Access Compliance Report

Public Rights-of-Way

(Curb Ramps)

Intersection ID: 5919	Main Street: GIBBON_RD	Cross Street: NEVIN_RD	Location:	S
ADA ID: 0BC4353B9C6F	Ramp Type: Perp	Initial Pass/Fail: Fail	Overall Compliance: No	Severity Score: 25
Codes/Mitigation Info/Possible Solution		Field Measurements/Component Compliance

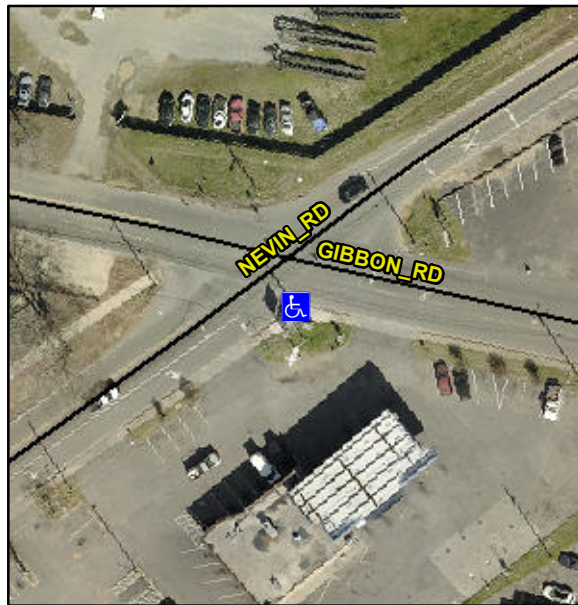
Not Found, R304.2.2

Compliance	Description	Data	Compliance	Description	Data
N/A	Ramp Length (in)	49.0	No	Ramp Slope (%)	12.2
Yes	Ramp Width (in)	48.0	Yes	Ramp XSlope (%)	1.9
N/A	Flare Type LT	N/A	N/A	Flare Type RT	N/A
N/A	Flare Slope LT (%)	N/A	N/A	Flare Slope RT (%)	N/A
N/A	Flare Traversable LT?	N/A	N/A	Flare Traversable RT?	N/A
N/A	Landing Length (in)	N/A	N/A	DWS Provided?	N/A
N/A	Landing Width (in)	N/A	N/A	DWS Contrast?	N/A
N/A	Landing Slope (%)	N/A	N/A	DWS Length (in)	N/A
N/A	Landing X Slope (%)	N/A	N/A	DWS Full Width?	N/A
N/A	Landing Curb? (Y/N)	N/A	N/A	DWS Offset (in)	N/A
N/A	Shared Landing?	N/A			
N/A	Gutter Ponding?	N/A	N/A	Gutter Slope (%)	N/A
N/A	Gutter Lip Ht (in)	N/A	N/A	Gutter X Slope (%)	N/A
N/A	Painted X Walk1?	No	N/A	Painted X Walk2?	N/A
	X Walk 1 Direction	To N		X Walk 2 Direction	N/A
N/A	X Walk 1 Width (in)	N/A	N/A	X Walk 2 Width (in)	N/A
	X Walk 1 Slope (%)	3.2		X Walk 2 Slope (%)	N/A
	X Walk 1 X Slope (%)	0.7		X Walk 2 X Slope (%)	N/A

Remove & Replace Entire Ramp.
